NOTICE OF REGULAR MEETING OF THE PLANNING AND ZONING COMMISSION REMOTE MEETING 1-888-475-4499 MEETING ID: 812 6961 6237 TUESDAY, MARCH 16, 2021, 6:00 PM

RE: Country Oak Estates Addition – Minor Replat, Lots 6A, 6C & 6D, Block A 1st Review

RE: Country Oak Estates Addition – Minor Replat, Lots 6A, 6C & 6D, Block A 2nd Review

Attachment: Site Plan Markup

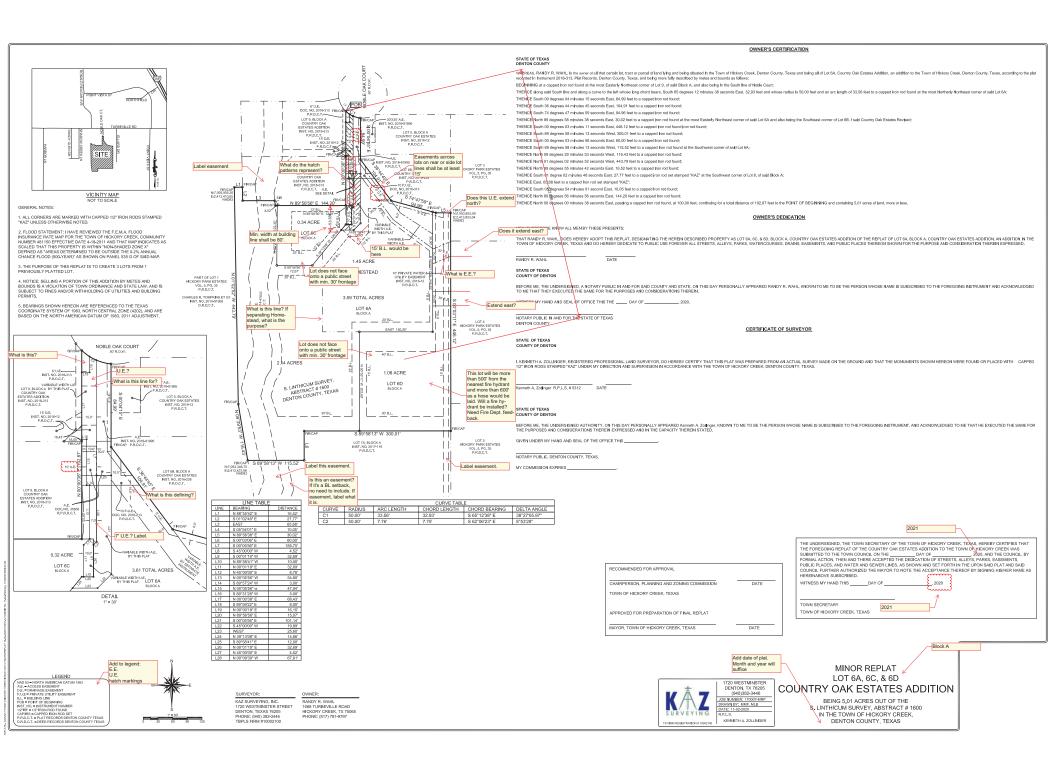
- 6. Per the Town's Engineering Design Manual, easements across lots on rear or side lot lines shall be at least 15 feet. There are several utility easements less than 15 feet wide adjacent to lot lines. (See markup.)

- 7. Please label all easements that are adjacent to the boundary. (See markup.)
- 8. Is there an easement east of the drainage easement on the adjacent lot south of the subject property? If so, label the easement. If it is a building line, please remove.

- 9. Do the two easements labeled E.E. extend east? (See markup.)
- 10. Does the utility easement on the north end od Lot 6D extend north? (See markup.)

- 11. In the detail:
 - a. What is the block in the northwest corner of Lot 6A? (See markup.)
 - b. What is the 10.0' label defining? (See markup.)
 - c. What is the area defined as 7.0' wide? Is it a utility easement? (See markup.)

- d. What is the dashed line near the northern end? (See markup.)
- 12. What is the dashed line in Lot 6A? (See markup.) If it is to separate the Homestead from the remainder of the lot, what is the purpose?

- 13. Per SF-3 zoning, the minimum width of the lot at the building line shall be 80 feet. Lot 6C measures approximately 53 feet at the building line. (See markup.)
- 14. What do the hatch patterns represent? (See markup.)
- 15. Please check the 15-foot building line on Lot 6A. (See markup.)
- 16. For single family homes, there should be a fire hydrant within 500 feet of the structure. Lot 6D will be located more than 500 feet from the hydrant located at the end of Noble Oak Court, and hose lay length appears to be more than 600 feet. Will there be a fire hydrant located to serve Lot 6D? It is recommended the fire department review the plat for access to proposed lots.
